UNITED STATES
DEPARTMENT OF THE INTERIOR
BUREAU OF LAND MANAGEMENTFORM APPROVED
OMB NO. 1004-0137
Expires: January 31, 2018**SUNDRY NOTICES AND REPORTS ON WELL HOBBBS OCD**
Do not use this form for proposals to drill or to re-enter an
abandoned well. Use form 3160-3 (APD) for such proposals.
AUG 21 2019**SUBMIT IN TRIPLICATE - Other instructions on page 2****RECEIVED**

Chevron USA respectfully requests the following changes to the originally approved APD:

CHEVRON U.S.A. INC.
PROPOSED PAD & ACCESS ROAD
COTTON DRAW IT TOWER SITE
SECTION 10, T25S-R32E
LEA COUNTY, NEW MEXICO

CHEVRON U.S.A. INC.
PROPOSED AST PAD
COTTON DRAW FACILITIES
SECTION 9, T25S-R32E
LEA COUNTY, NEW MEXICO

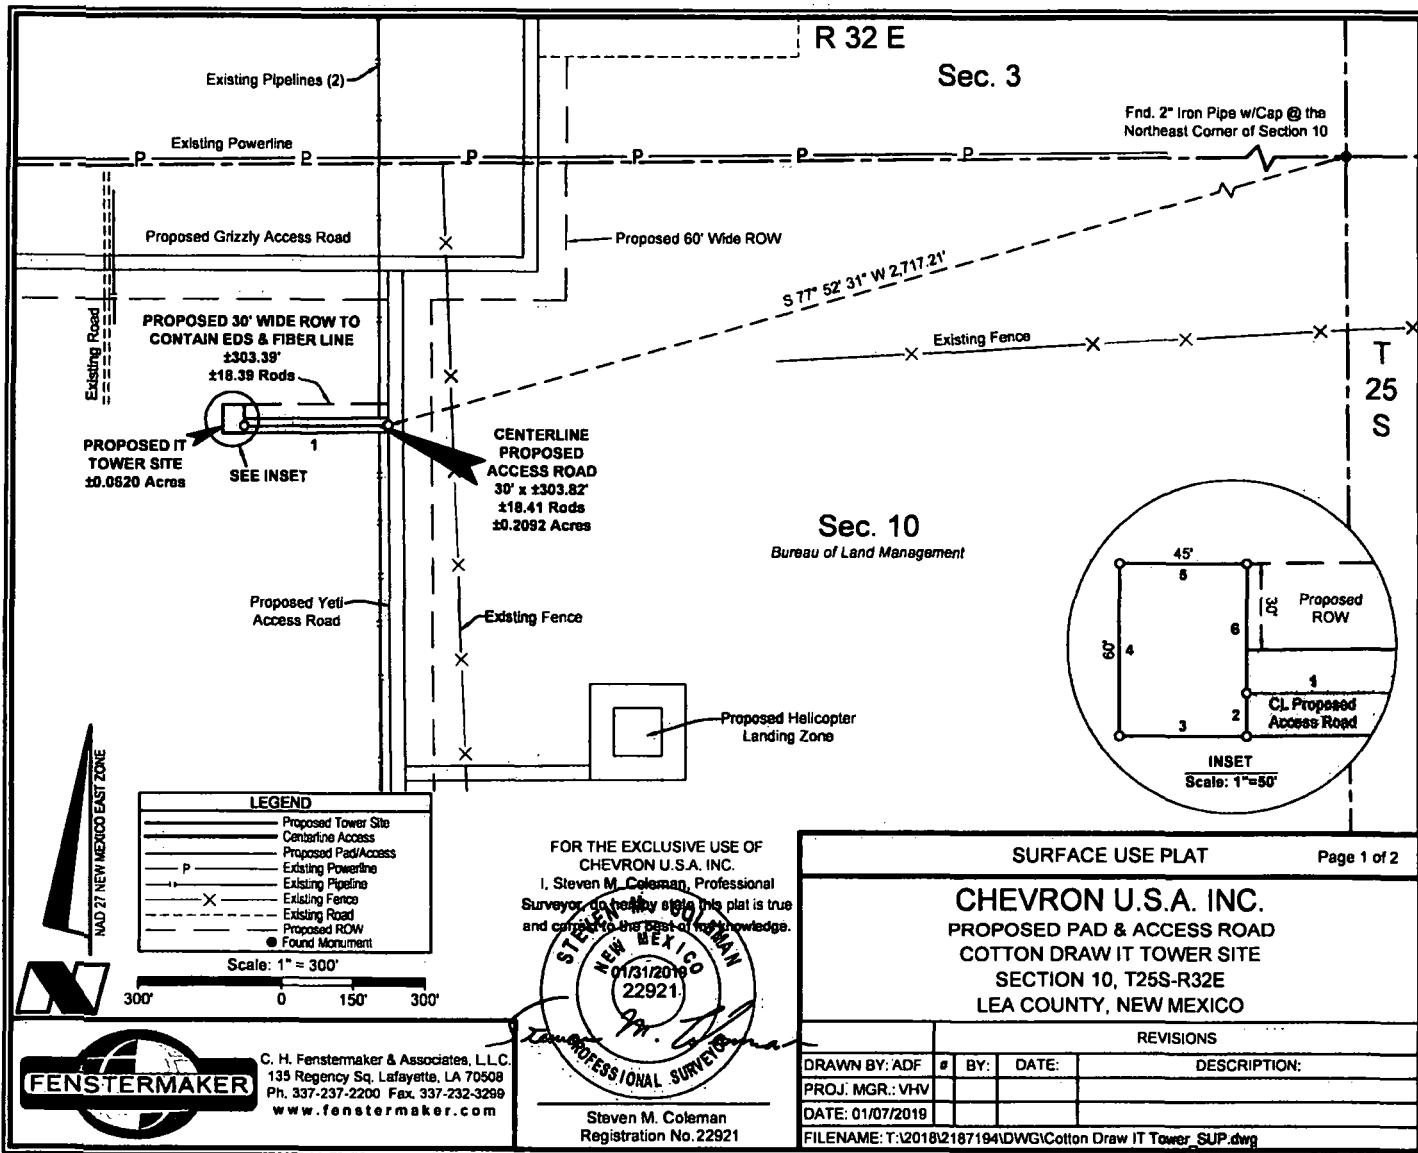
- IT Tower: In order for the field to have remote monitoring and to optimize the field's safety by having the facilities communicate with each other, an IT Tower for continuous & reliable communication is required. Chevron USA Inc. will be the only user, any subsequent users will acquire an additional lease directly from the BLM. The access road for the Cotton Draw IT Tower is 30' wide x 303.82' long and the EDS/Fiber ROW is 30' wide x 303.39' long.

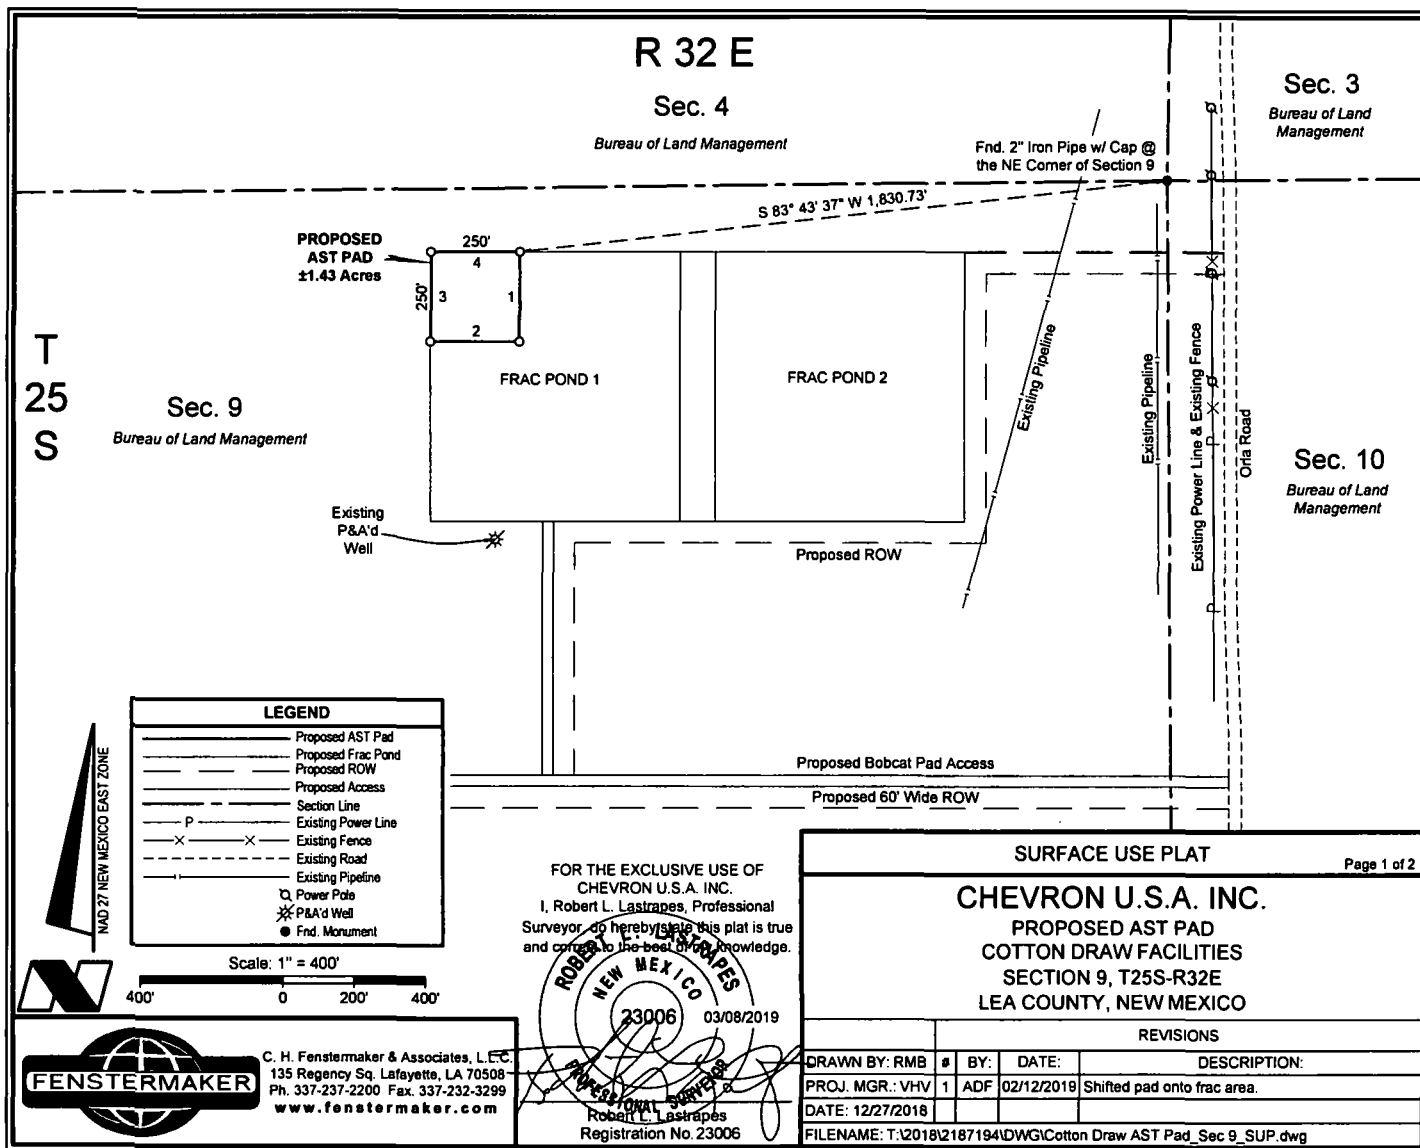
- AST Pad: Drilling operations requires a small amount of fresh water for surface drilling, as does the construction of the Frac Pond. The Cotton Draw development does not have a freshwater pond

planned. The proposal is to build an AST Pad in the NW corner of the permitted Frac Pond to temporarily supply water during drilling of the Yeti Pad & construction of the 1st cell of the Frac Pond. The 2nd cell of the Frac Pond will be constructed leveraging water stored in the 1st cell of the frac pond. This will significantly minimize truck traffic in the field.

DRAWN BY:	RMB	#	BY:	DATE:	DESCRIPTION:
PROJ. MGR.:	VHV	1	ADF	02/12/2019	Shifted pad onto frac area.
DATE:	12/27/2018				
FILENAME: T:\2018\2187194\DWG\Cotton Draw AST Pad_Sec 9_SUP.dwg

CHEVRON U.S.A. INC.
PROPOSED OPS AREA
COTTON DRAW FACILITIES
SECTION 10, T25S-R32E
LEA COUNTY, NEW MEXICO

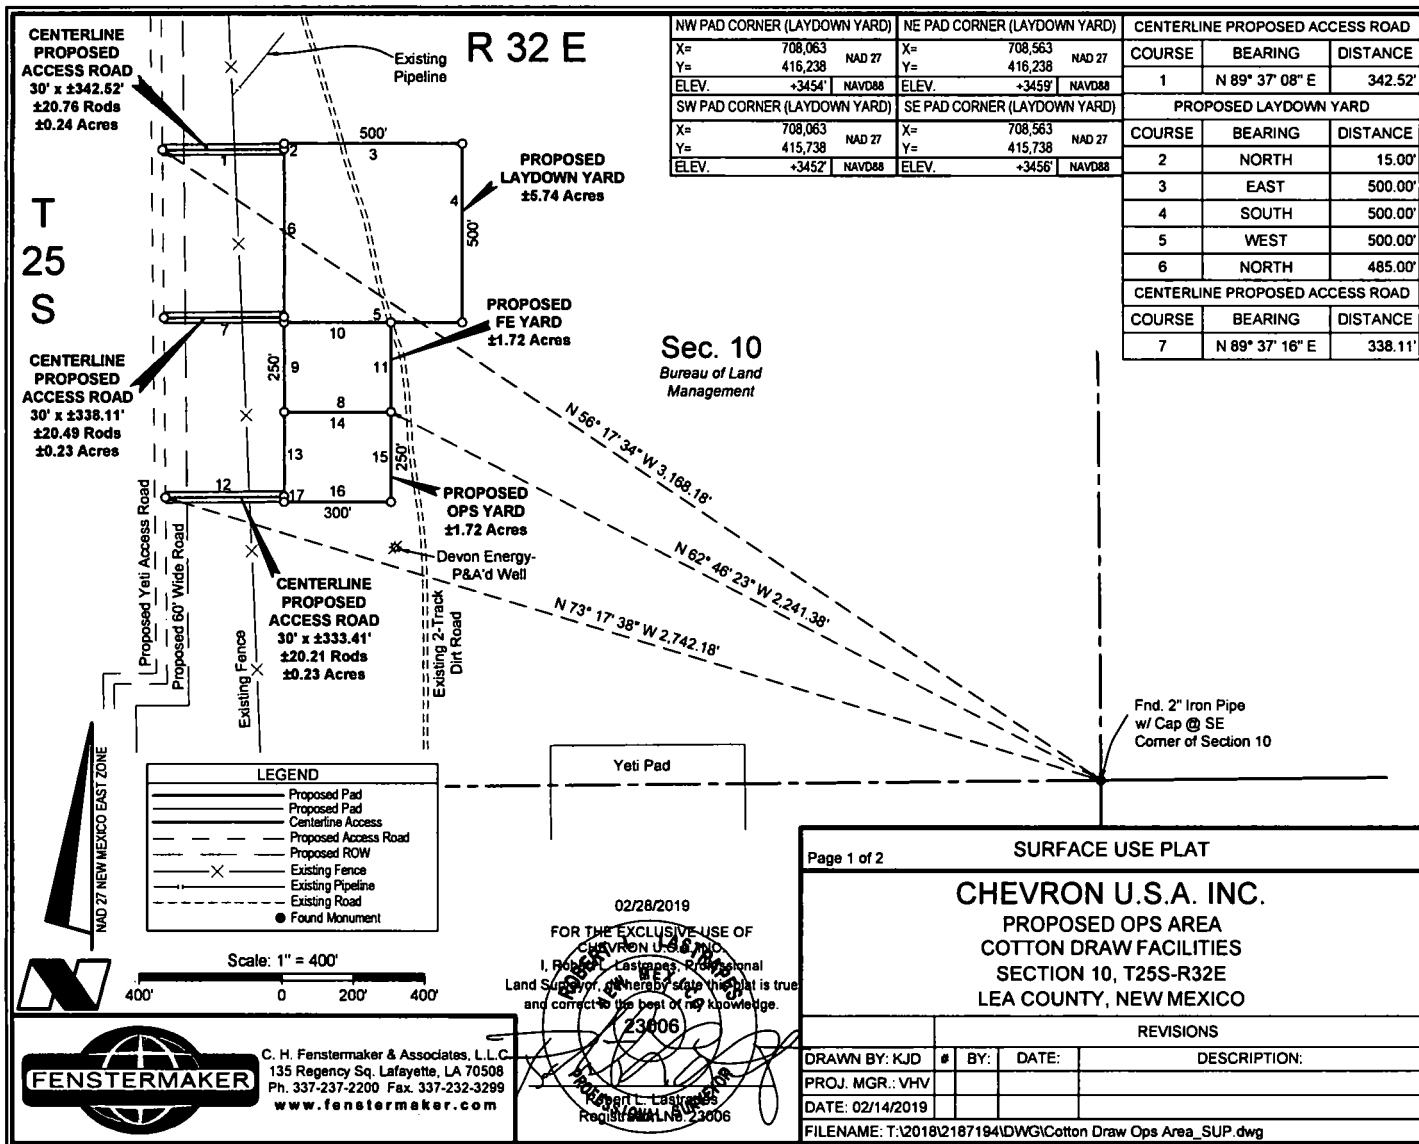
- 500'x500' Laydown Yard: The Laydown Yard is for the temporary storage of major equipment/vessels & piping during the development of a field. Due to the significant infrastructure required to develop a new production field without existing infrastructure, a Laydown Yard allows for the storage of long lead items and for quick/easy access during the construction process. There will not be any waste water tanks, the area will only be used to house materials & equipment.

- 250'x300' FE Yard & 250'x300' Operations Yard: The FE & Operations Yards will act as offices and, for the FE Yard, housing with power, sewage, & running water with above surface holding tank. These FE & Operations Yards allow for continuous monitoring of the field and minimize the response time to either upset events during operations or issues during construction.
